Longfield Solar Farm Draft position statement on Landscape and Visual Impact

Prepared for: Essex County Council,
Chelmsford City Council, Braintree District
Council

14th July 2022

Cumulative Development Plan

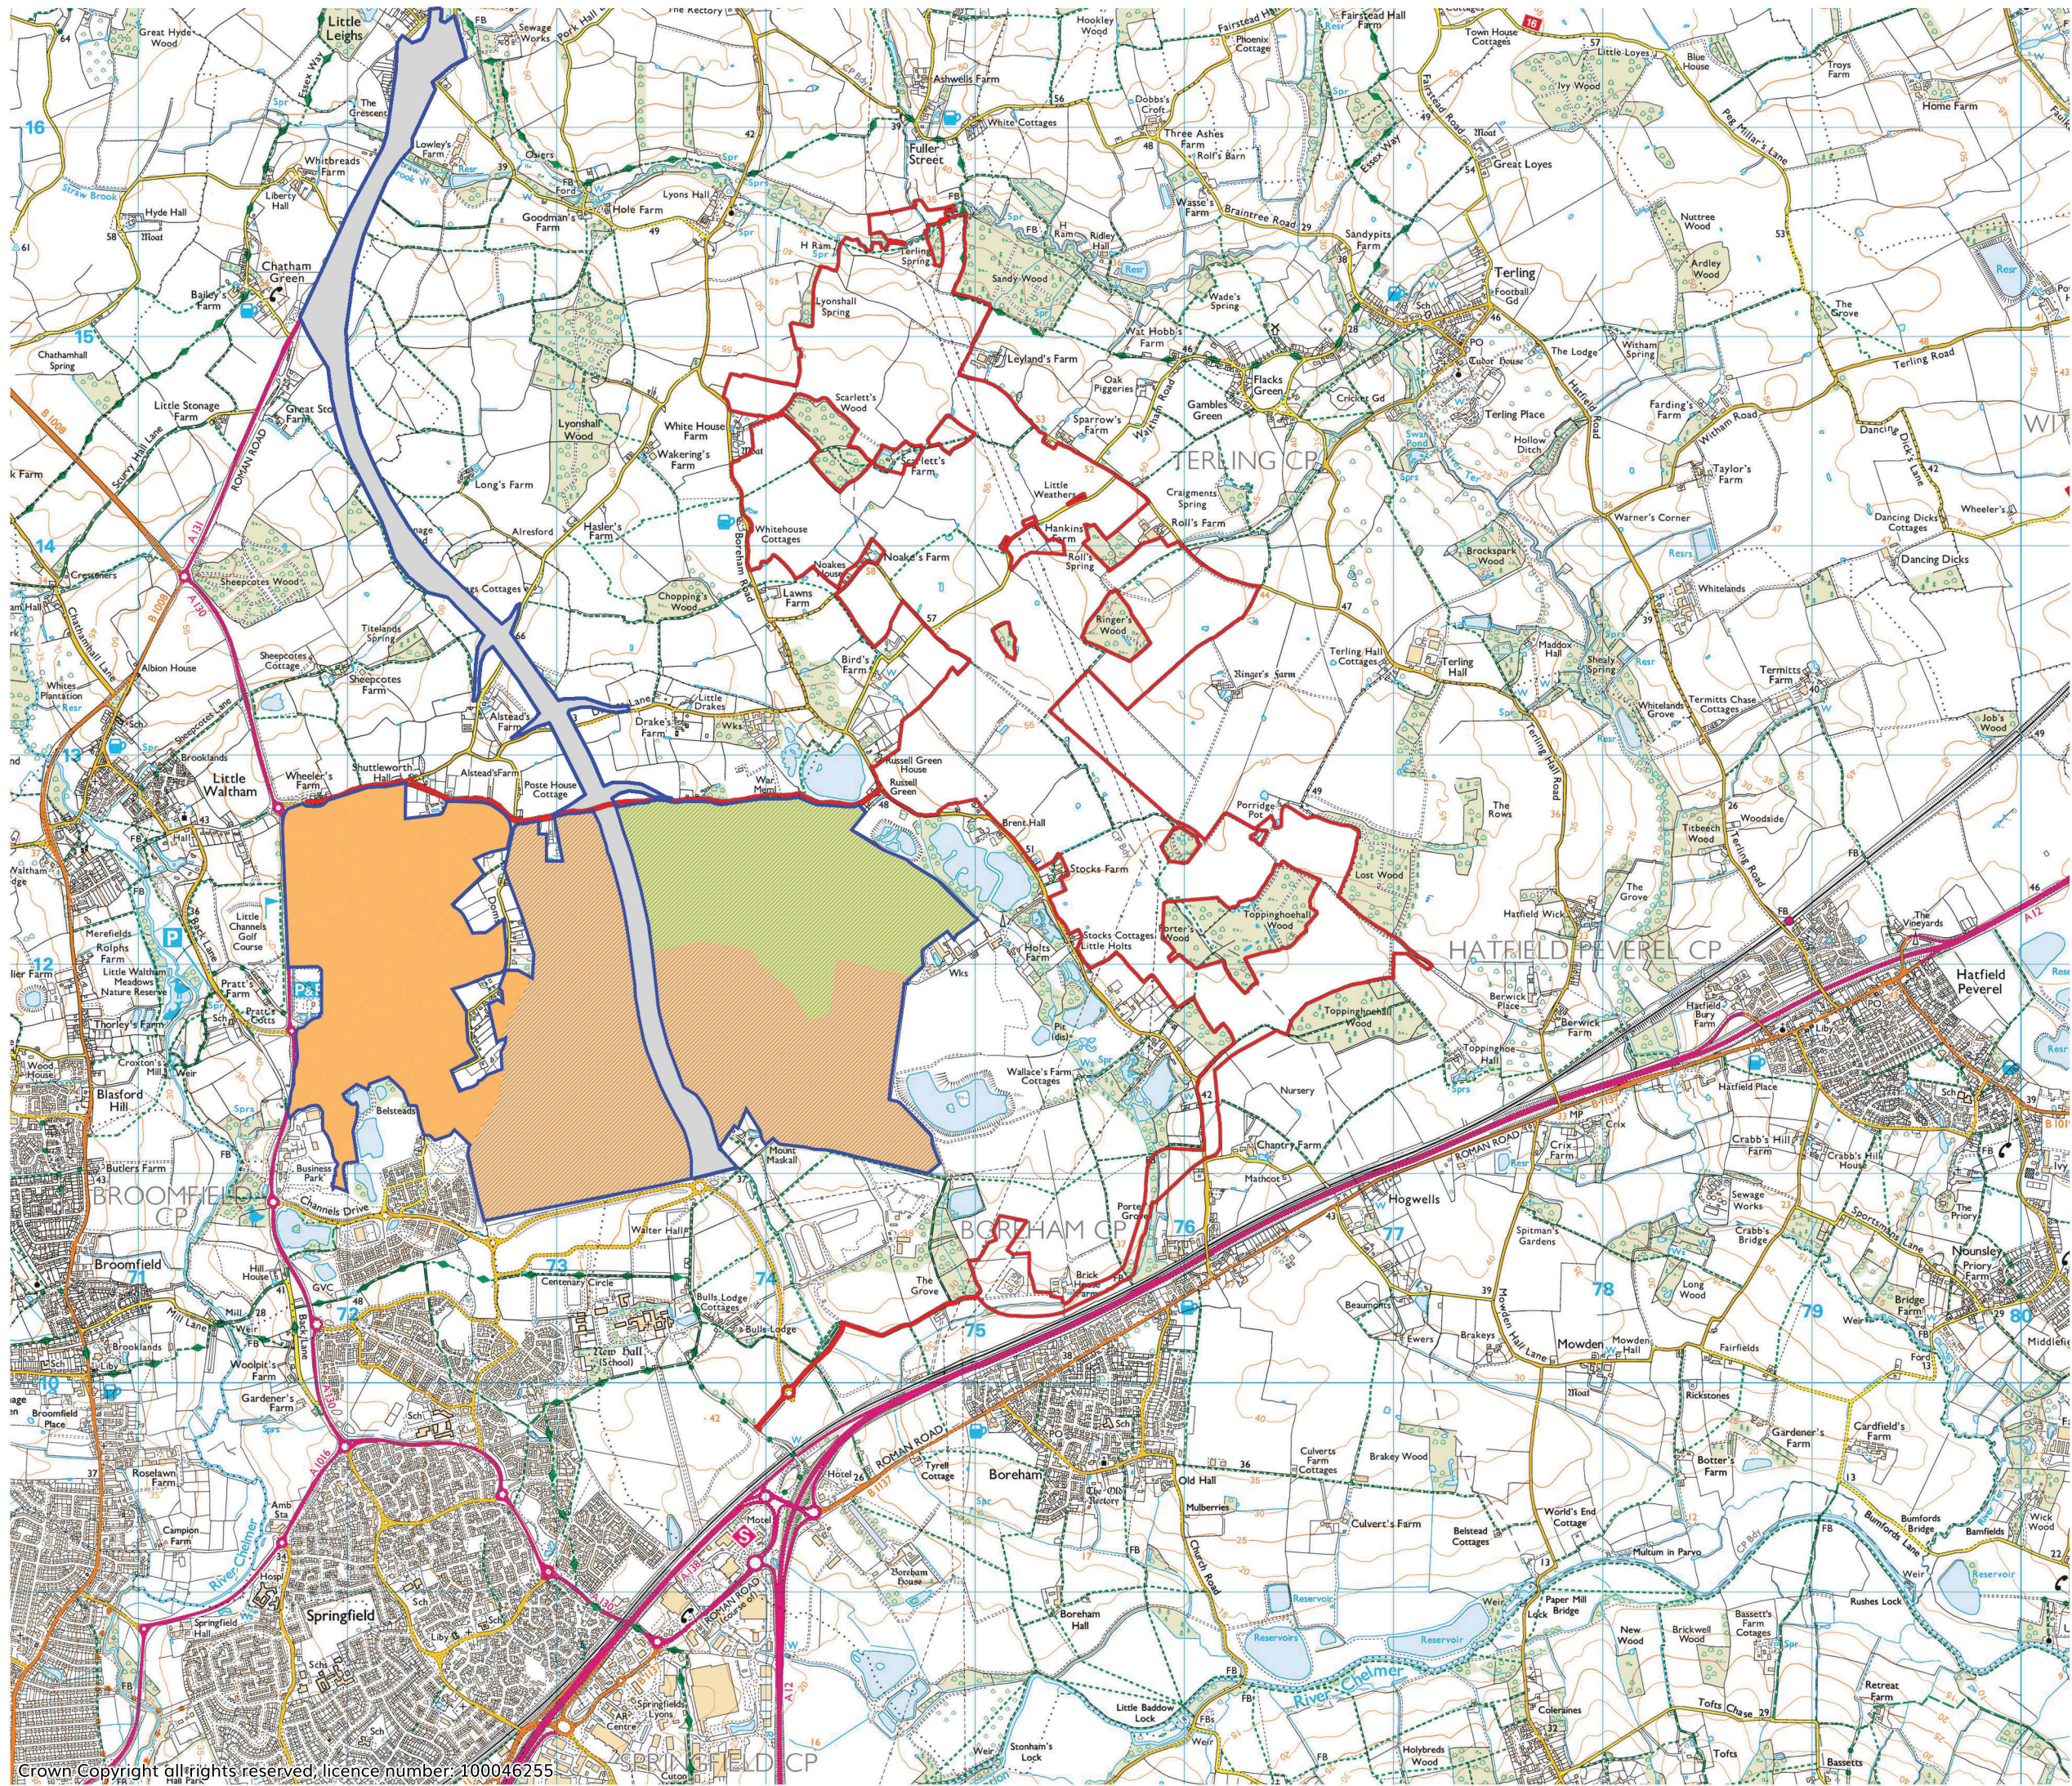
The ES falls short of describing the combined cumulative effect across the two District LCAs and spatially mapping of the Chelmsford North-Eastern Urban Extension and other developments in combination with the Longfield proposal.

When the major developments of the North-eastern Urban extension to Chelmsford, the Chelmsford Garden Village and the Chelmsford Northern By-pass and Longfield are mapped it is clear that if all developments went ahead there will be an erosion of the countryside buffer between Chelmsford and Terling. Assessment of the impact of the proposed major developments will only be undertaken at the time that they come forward as part of the planning process, however, it is likely that any assessment would find adverse impacts from the development of open countryside to a major housing scheme or new infrastructure project. When combined with Longfield's effect on the Terling Farmland plateau the cumulative effect is likely to be a moderate adverse effect on the two character areas.

The following map illustrates the spatial arrangement of the proposed major developments.
